CITY OF MEXICO BEACH
4TH STREET STORMWATER IMPROVEMENTS PROJECT

**ADDENDUM NO. 2
REQUESTS FOR INFORMATION**

Issued August 21, 2025

THIS SHEET NOT VALID FOR CONSTRUCTION WITHOUT COMPLETE SET OF PLANS. SEE GENERAL NOTES FOR MASTER LEGEND.
 Sheet No.
C1.0

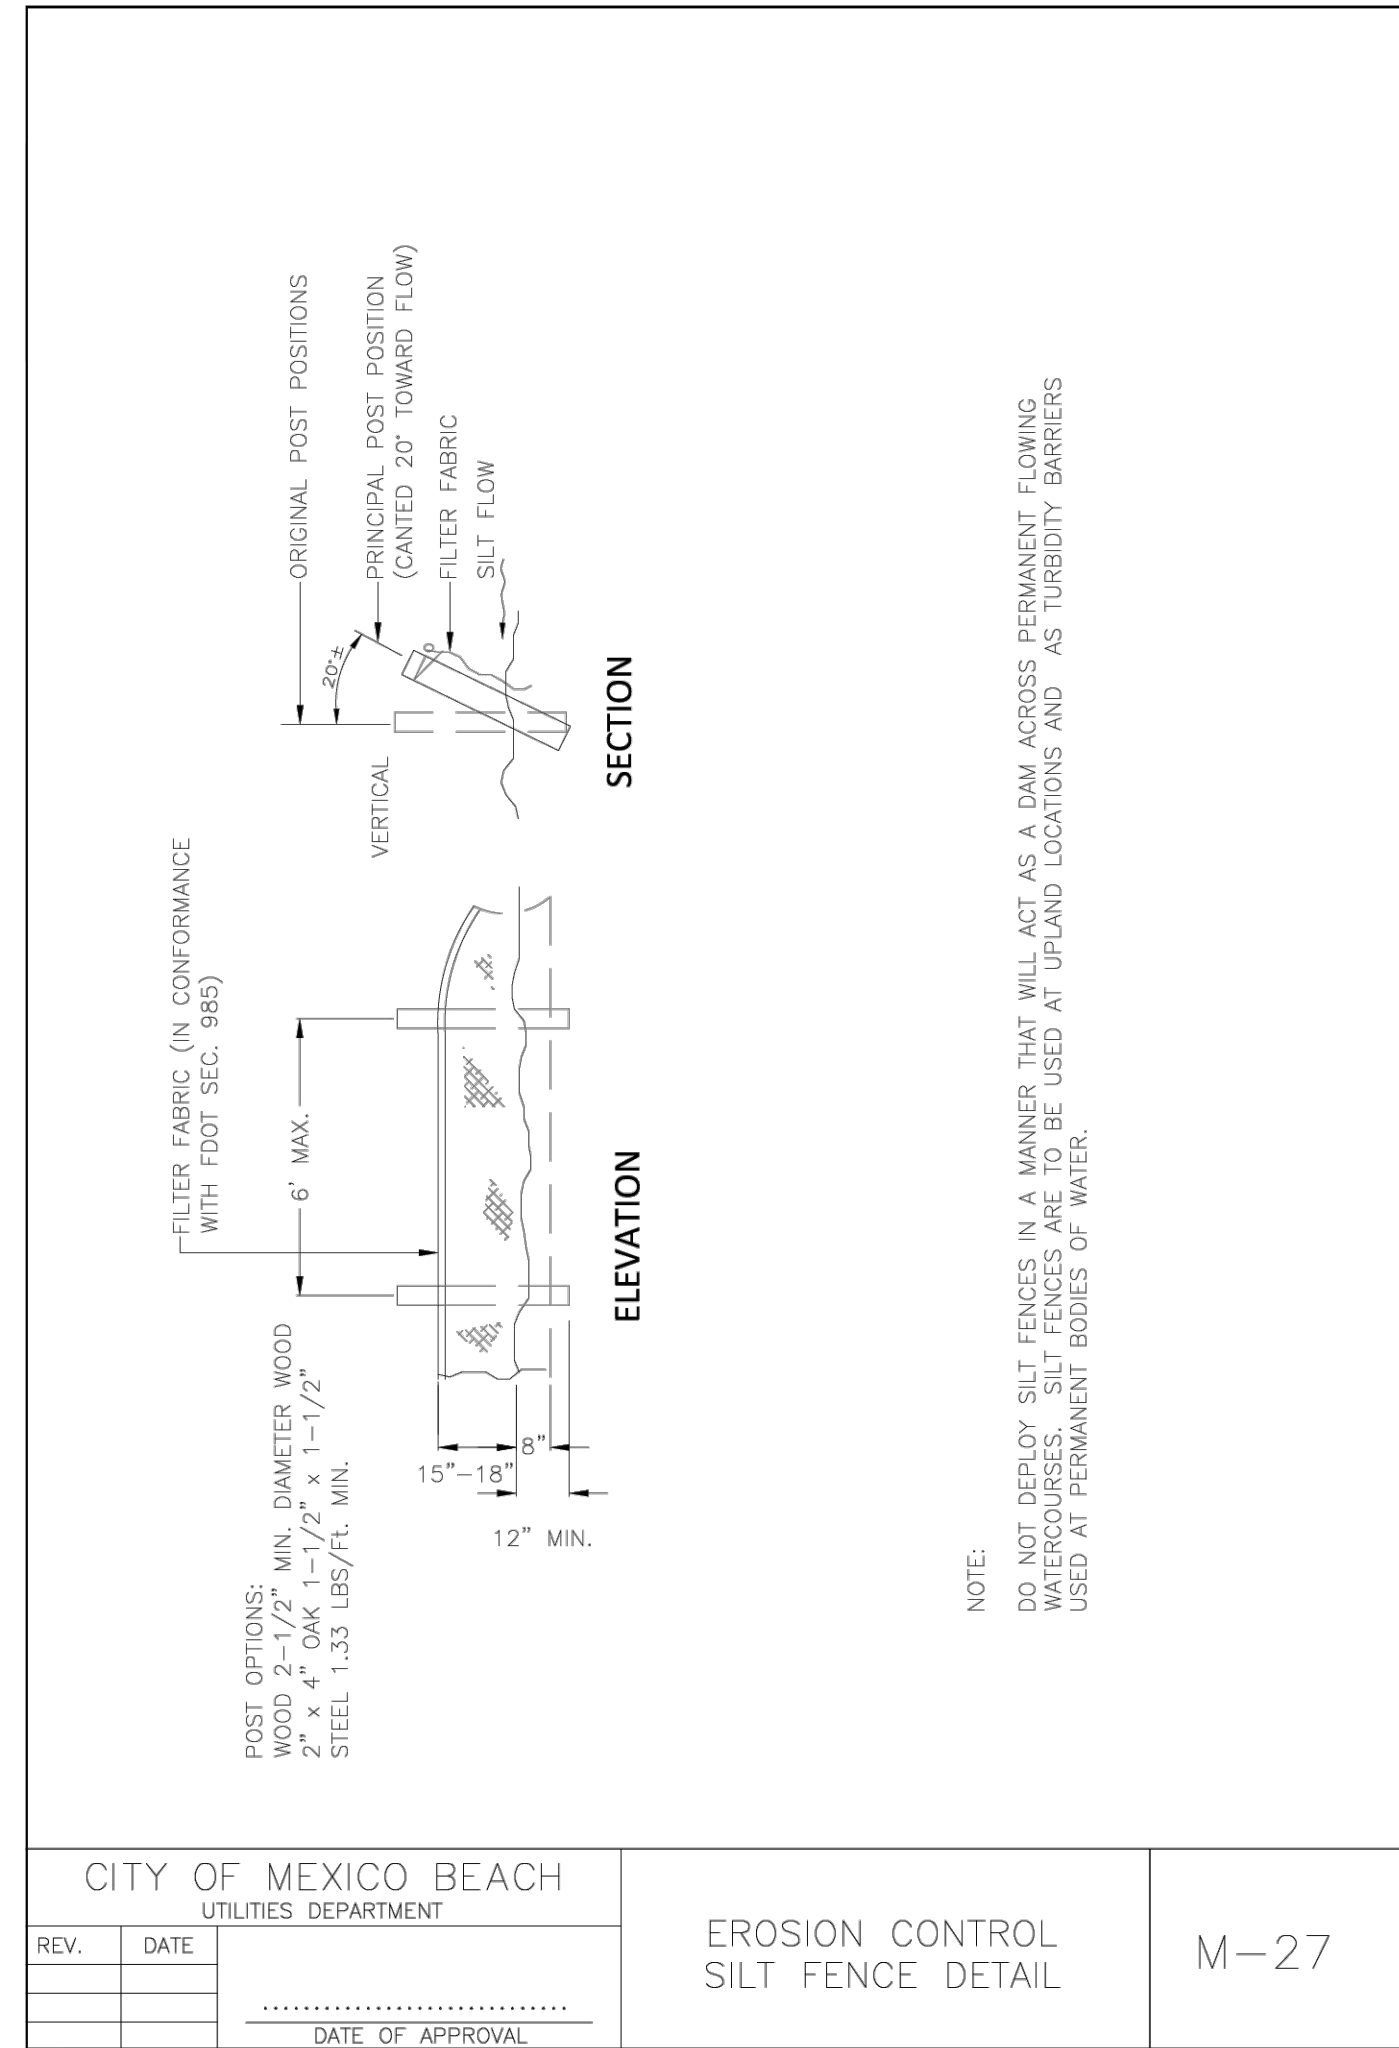
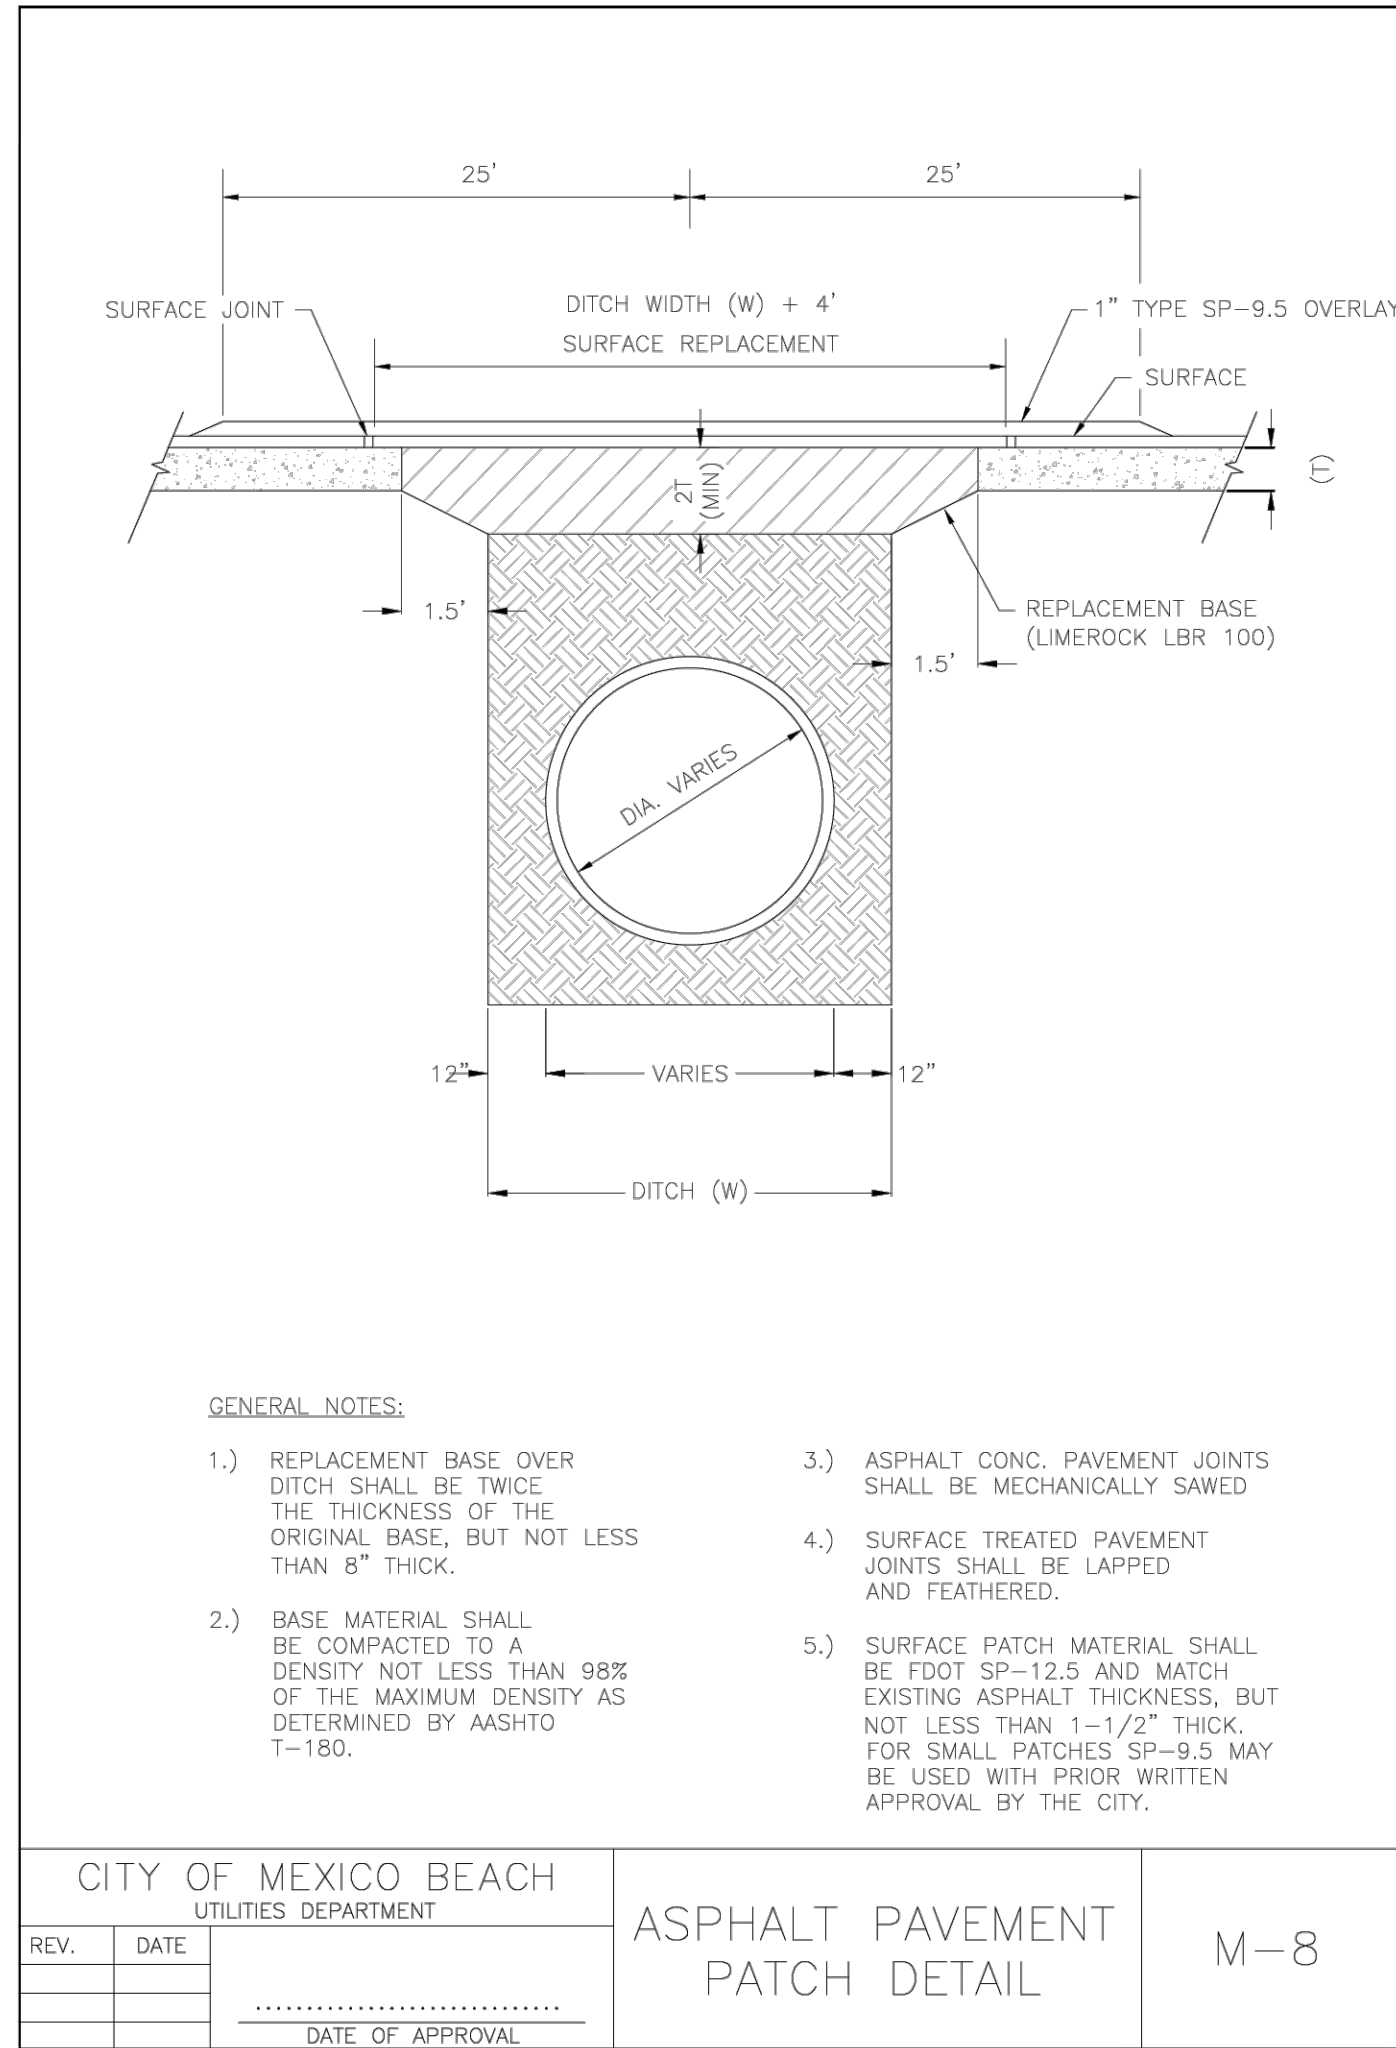
1. Is the scale verified @ 1" = 30' ? A few people had problems with it.

City's Response to Request for Information Question No. 1: The scale on sheet C1.0 was incorrect. See attached revised drawings
